Access Compliance Report

Public Rights-of-Way

Intersection ID: 50494	Main Street: BLAIREBETH_ST	Cross Street: HAWFIELD_WAY_DR	Location: NE
ADA ID: A0BCBC6573CF	Ramp Type: PerpDiag	Initial Pass/Fail: Fail	Overall Compliance: No
		Severity Score: 25

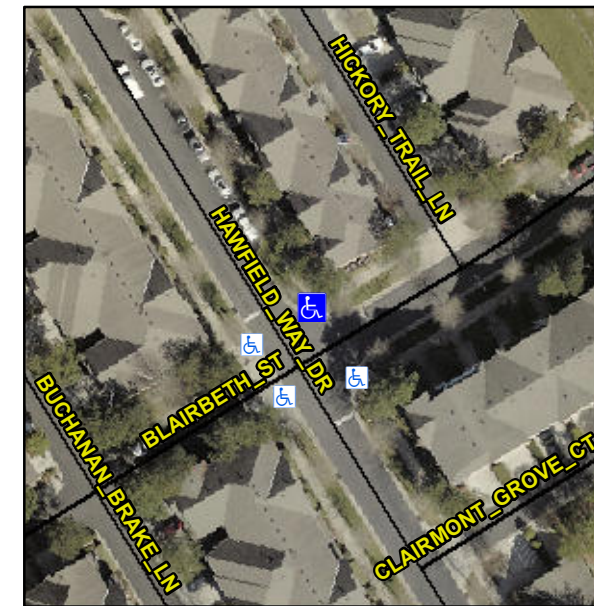
Not Found, R304.5.3

Compliance	Description	Data	Compliance	Description	Data
N/A	Ramp Length (in)	97.0	Yes	Ramp Slope (%)	6.8
Yes	Ramp Width (in)	48.0	No	Ramp XSlope (%)	7.7
N/A	Flare Type LT	N/A	N/A	Flare Type RT	N/A
N/A	Flare Slope LT (%)	N/A	N/A	Flare Slope RT (%)	N/A
N/A	Flare Traversable LT?	N/A	N/A	Flare Traversable RT?	N/A
N/A	Landing Length (in)	N/A	N/A	DWS Provided?	N/A
N/A	Landing Width (in)	N/A	N/A	DWS Contrast?	N/A
N/A	Landing Slope (%)	N/A	N/A	DWS Length (in)	N/A
N/A	Landing X Slope (%)	N/A	N/A	DWS Full Width?	N/A
N/A	Landing Curb? (Y/N)	N/A	N/A	DWS Offset (in)	N/A
N/A	Shared Landing?	N/A			
N/A	Gutter Ponding?	N/A	N/A	Gutter Slope (%)	N/A
N/A	Gutter Lip Ht (in)	N/A	N/A	Gutter X Slope (%)	N/A
N/A	Painted X Walk1?	No	N/A	Painted X Walk2?	No
	X Walk 1 Direction	To SW		X Walk 2 Direction	To SE
N/A	X Walk 1 Width (in)	N/A	N/A	X Walk 2 Width (in)	N/A
	X Walk 1 Slope (%)	2.6		X Walk 2 Slope (%)	0.0
	X Walk 1 X Slope (%)	1.2		X Walk 2 X Slope (%)	3.0

Remove & Replace Curb Ramp With Two New Directional Ramps or Equivalent.
